LITTLE COLORADO RIVER 2 LEVEE SYSTEM

CITY OF HOLBROOK, NAVAJO COUNTY, ARIZONA NLD SYSTEM ID # 3805020011

PERIODIC INSPECTION REPORT NO 1
GENERALIZED EXECUTIVE SUMMARY

FINAL SYSTEM RATING: MINIMALLY ACCEPTABLE FINAL RATING DATE: APRIL 21, 2015

Page 4 of 4 Figure 1-1

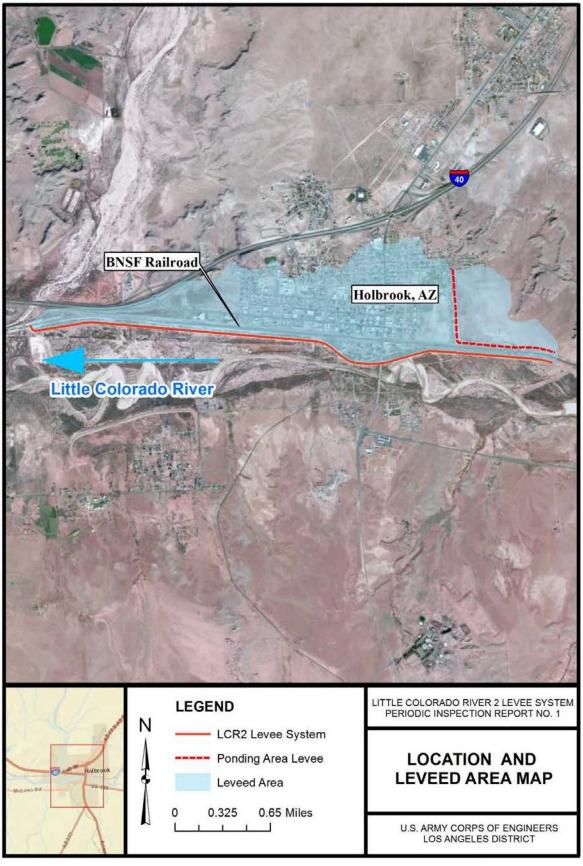
The Holbrook Levee Project consists of two levee systems constructed along the Little Colorado River in the City of Holbrook, Arizona (Figure 1-1). The left/north bank of the Little Colorado River is the LCR2 Levee System and is also known as the North Levee. The levee on the right/south bank of the Little Colorado River is the Little Colorado River 1 (LCR1) Levee System and is also known as the McLaws Levee. Both levee systems were inspected on April 8, 2014. A separate Periodic Inspection Report No. 1 has been developed for the LCR1 Levee System.
